October 31, 1994

DOCKETS 50-266 AND 50-301
RESPONSE TO THE REQUEST FOR ADDITIONAL INFORMATION REGARDING
REQUEST FOR EXEMPTION FROM THE REQUIREMENTS OF SECTION III.G OF
APPENDIX R TO 10 CFR 50 FOR THE AUXILIARY FEEDWATER PUMP ROOM
POINT BEACH NUCLEAR PLANT, UNITS 1 AND 2

ATTACHMENT 1
RESPONSE TO THE REQUEST FOR ADDITIONAL INFORMATION
APPENDIX R EXEMPTION REQUEST

FIRESTOP
ELECTRICAL CABLE TRAY
HORIZONTAL/VERTICAL

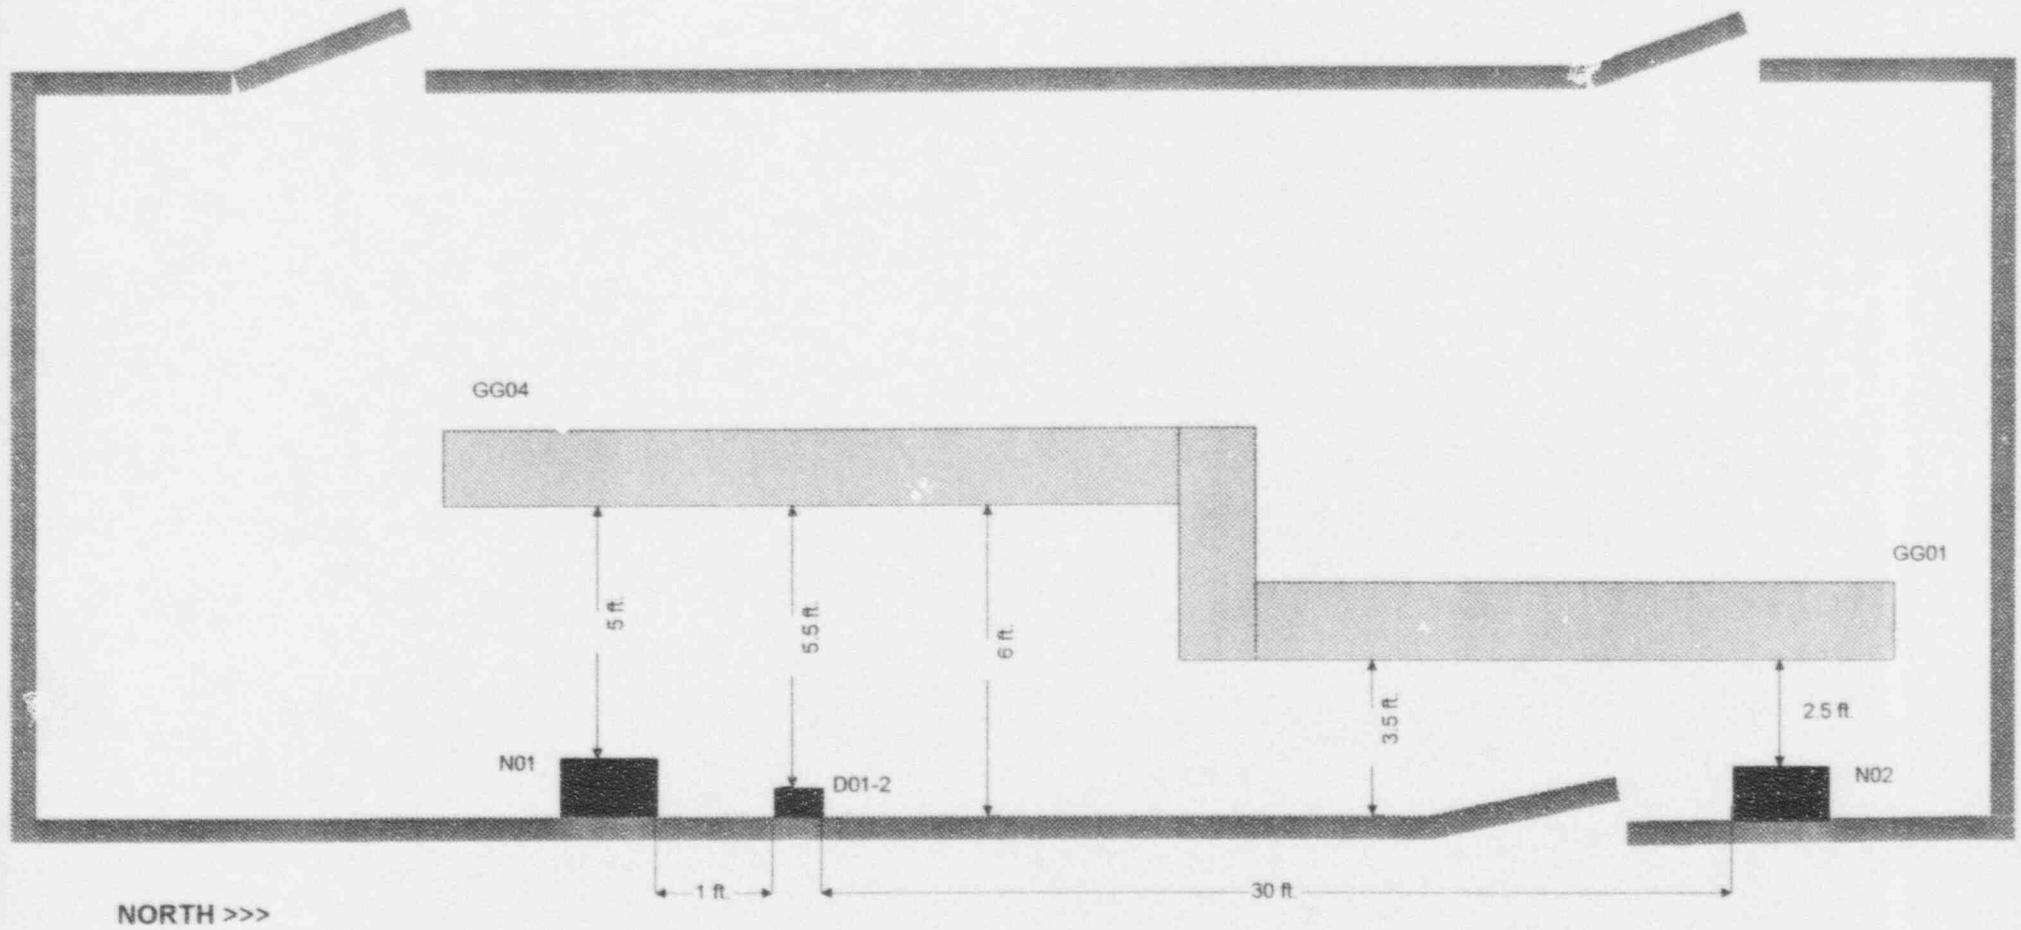
- 6.0 Provide specific details concerning the cable tray "fire breaks" installed in each end of the enclosed trays. Include the type of material used and the fire test or industry standard used to qualify the assembly as an adequate fire stop.

The intent in providing fire breaks is to limit flame propagation through passive protection. The proposed fire break design has been fire tested and approved by American Nuclear Insurers in accordance with the requirements in Revision 0 of American Nuclear Insurer's "Guidelines for Cable Tray Fire Breaks", dated November 1987. Each cable tray fire break will consist of nine inches of silicone foam with one inch of carborundum fiberfax damming material on each side. The silicone foam will fill the full depth of the cable tray. Additionally, this fire break will be covered by a metal tray cover at least three feet in length, centered over the fire stop. A representative drawing of the proposed fire break is provided in Attachment 2.

ATTACHMENT 3
HORIZONTAL
SEPARATION
DISTANCES
(TOP VIEW)

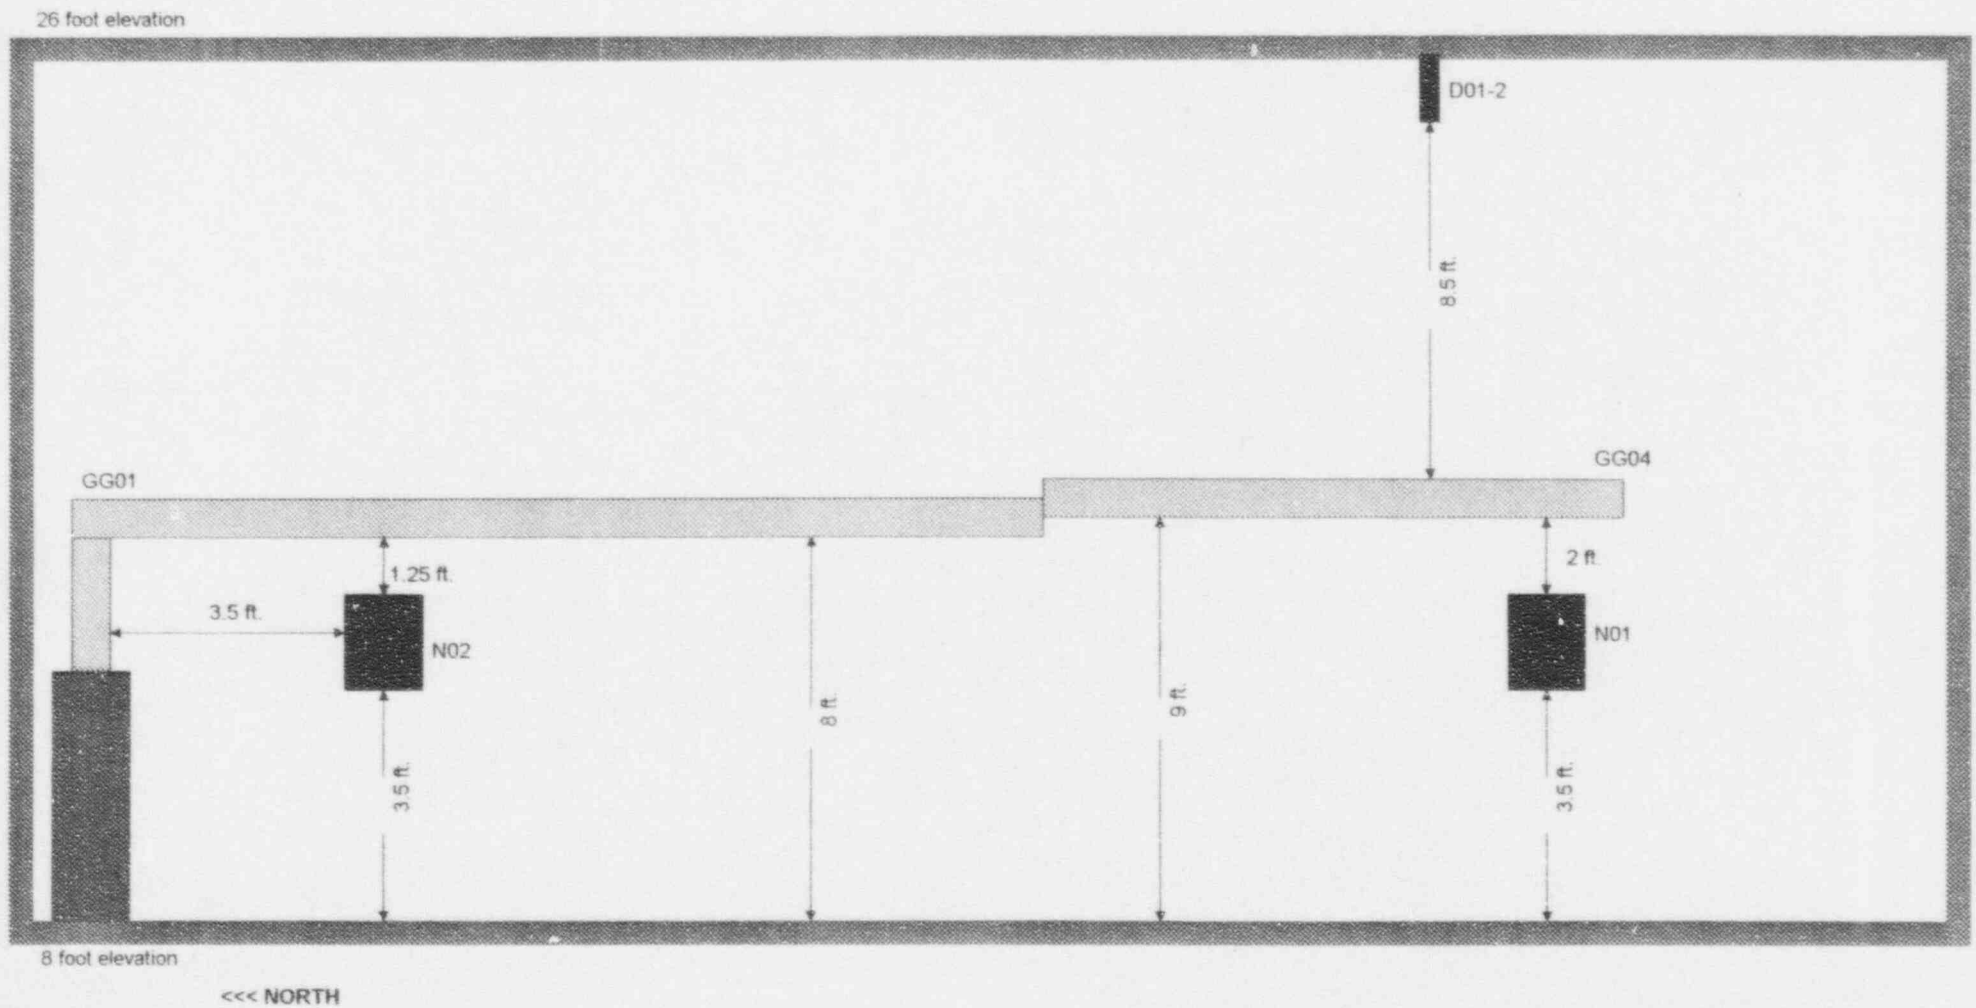
12.0 Specify the horizontal and vertical separation of Cable Tray G-04 from local Control Panels A and B and Conduit D01-2.

The requested horizontal separation distances are provided in Attachment 3. The requested vertical separation distances are provided in Attachment 4.

Attachment 7

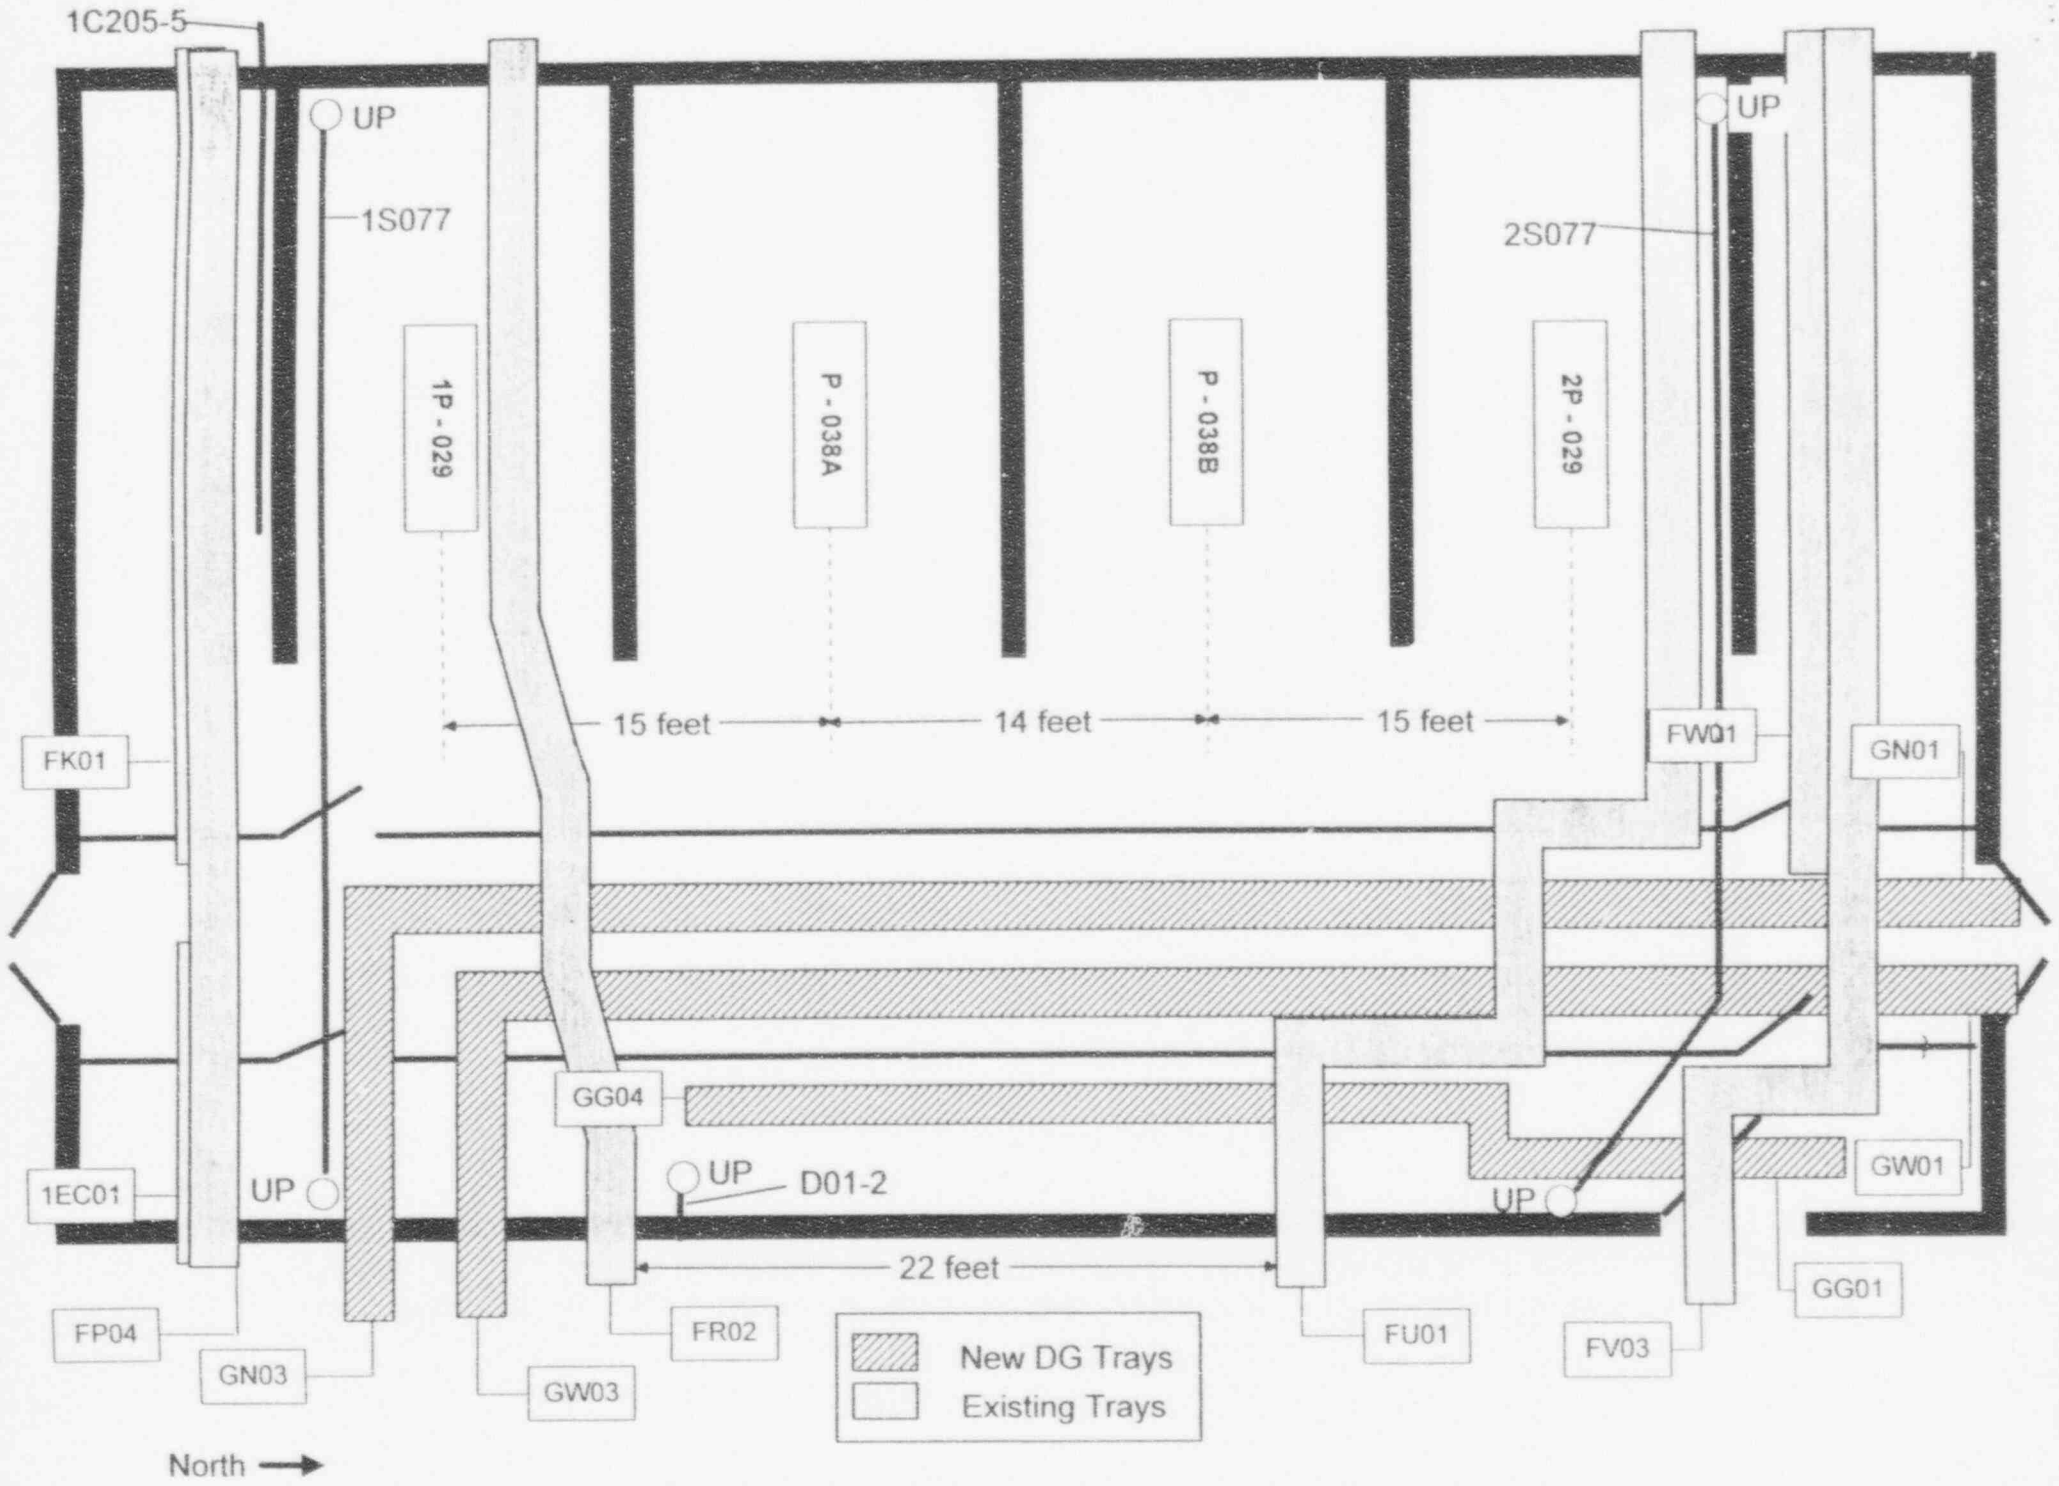
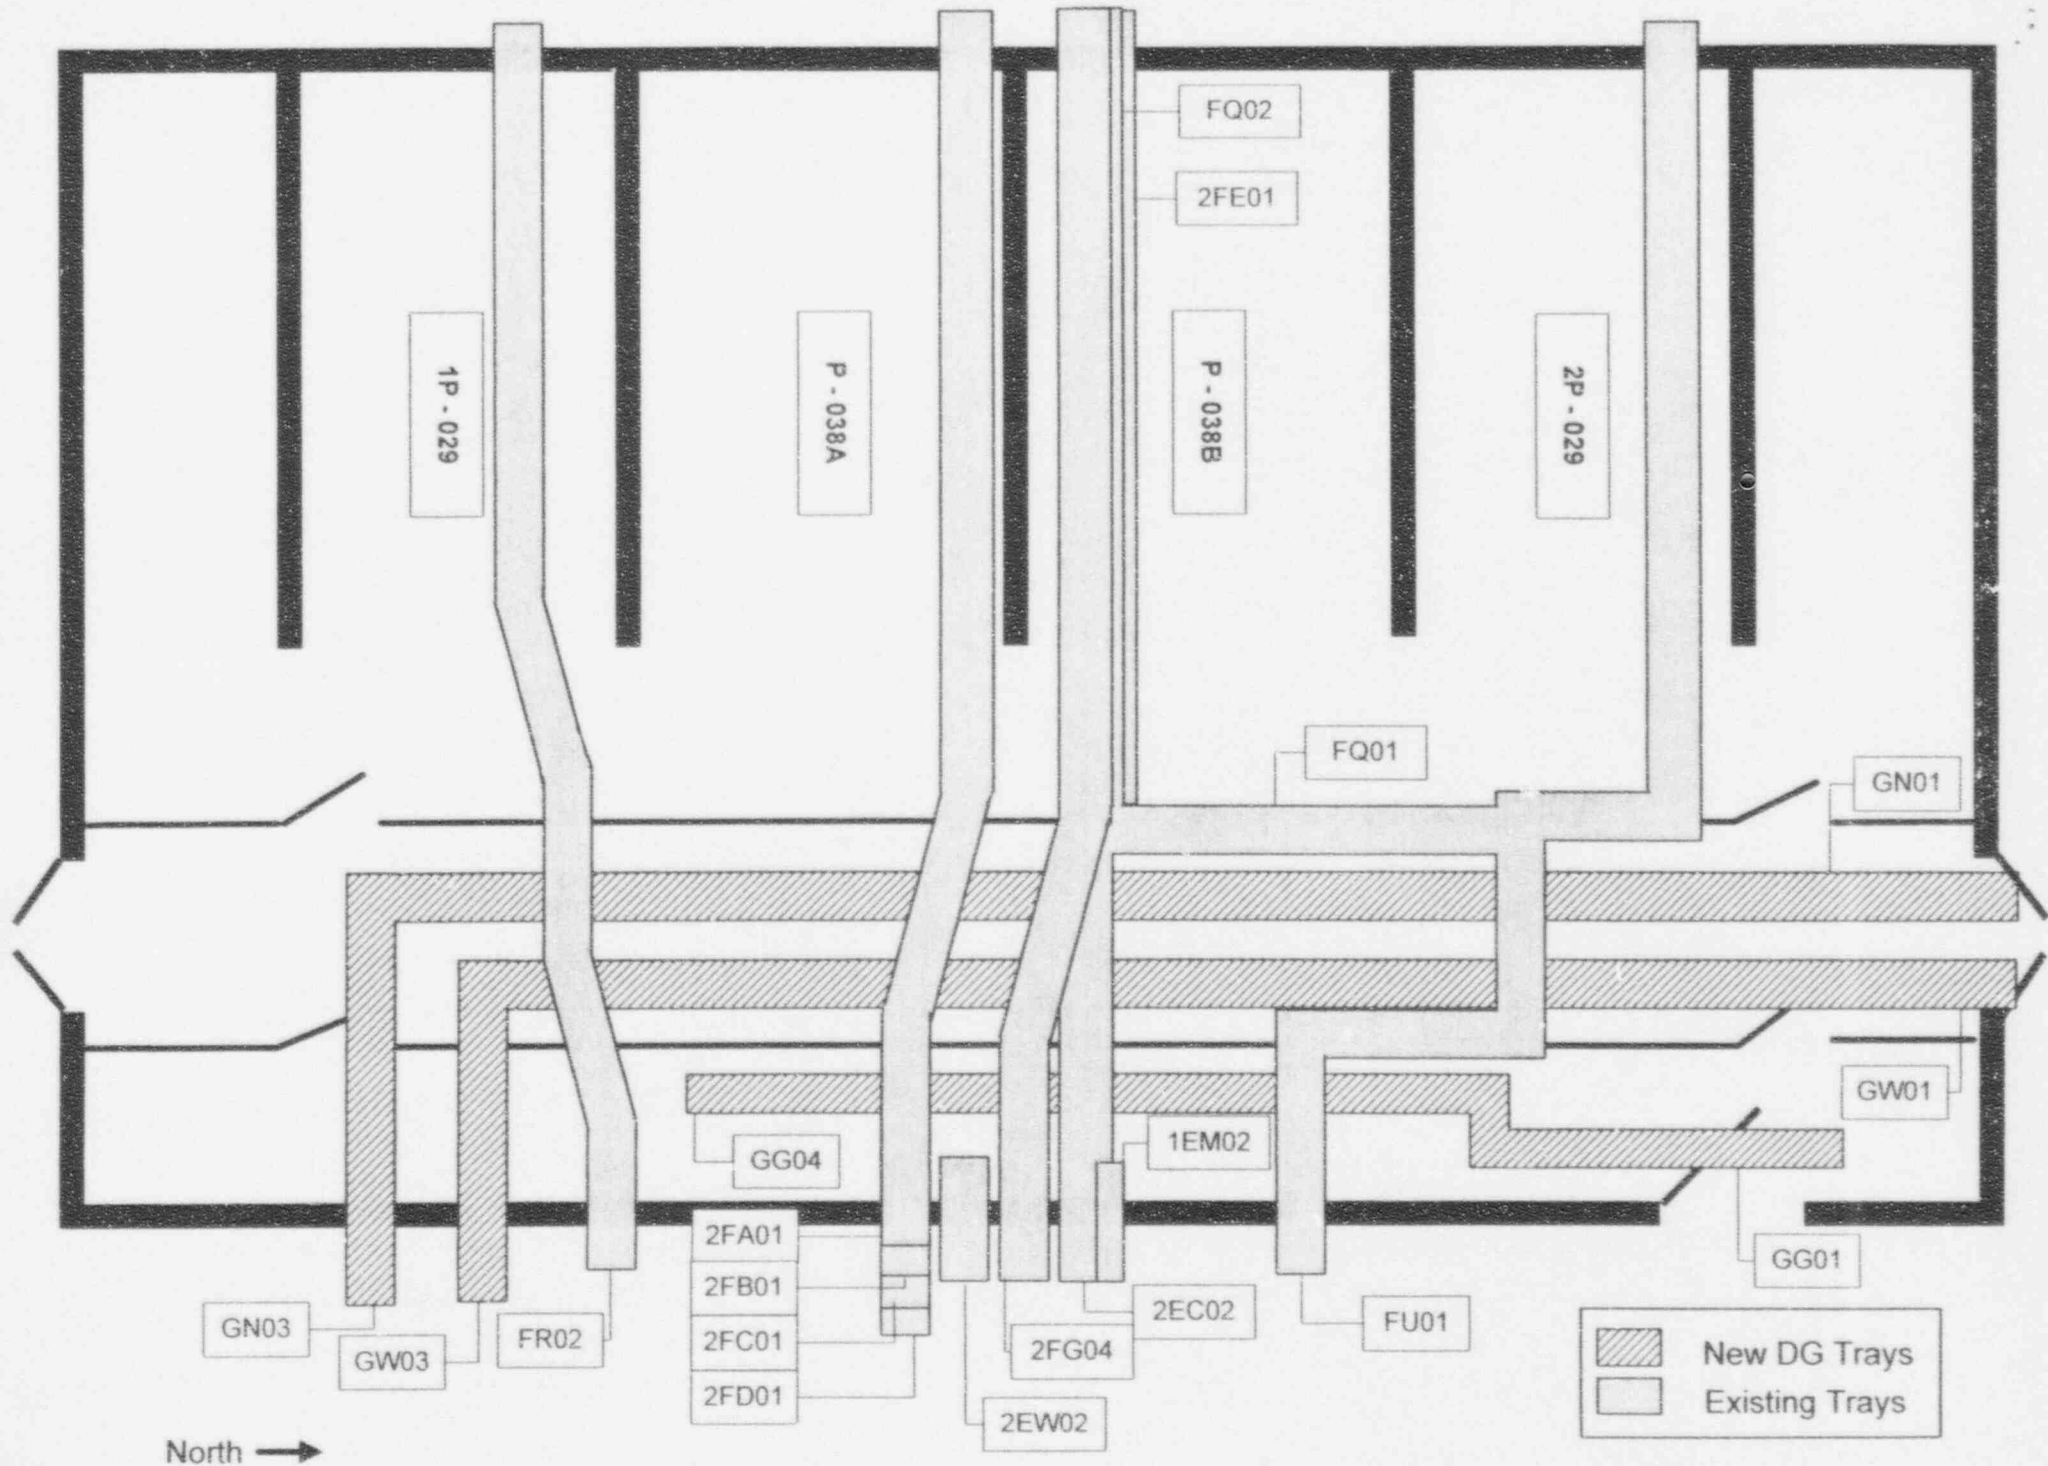
- 3.0 Describe the types and applications of all cables that are considered as intervening combustibles and present an exposure hazard to the redundant trains of safe shutdown equipment and cabling. Specify if the cables are IEEE-383 qualified or not and whether the cables are used for power,

control or instrumentation. Provide a diagram showing all cable trays that are considered as a intervening combustible between redundant trains of all safe shutdown components located in this fire area, including those addressed under the 1985 exemption. Identify the function of the existing cable tray located at the northern end of the auxiliary feedwater pump room depicted in Attachment 2 of the August 5, 1994, exemption request that is not labeled.

The requested information concerning the cables that are considered as intervening combustibles is contained in Attachment 6. A diagram showing all cable trays that are considered as intervening combustibles is provided in Attachments 7 and 8. The cable tray at the northern end of the auxiliary feedwater pump room that was not identified in our previous submittal is FV03 and is indicated on Attachment 7. Additionally, it should be noted that the majority of cables installed in the auxiliary feedwater pump room are not IEEE 383 qualified because they are original plant design. However, all of the cables installed as part of the diesel generator addition project are IEEE 383 qualified.

The routing of the cable trays of concern and those in the 20-foot intervening separation space are shown in Attachments 7 and 8. As described in our previous submittals, this cable tray arrangement does not provide a combustible pathway for fire to spread across the separation space between redundant safe shutdown cables and equipment in the room.
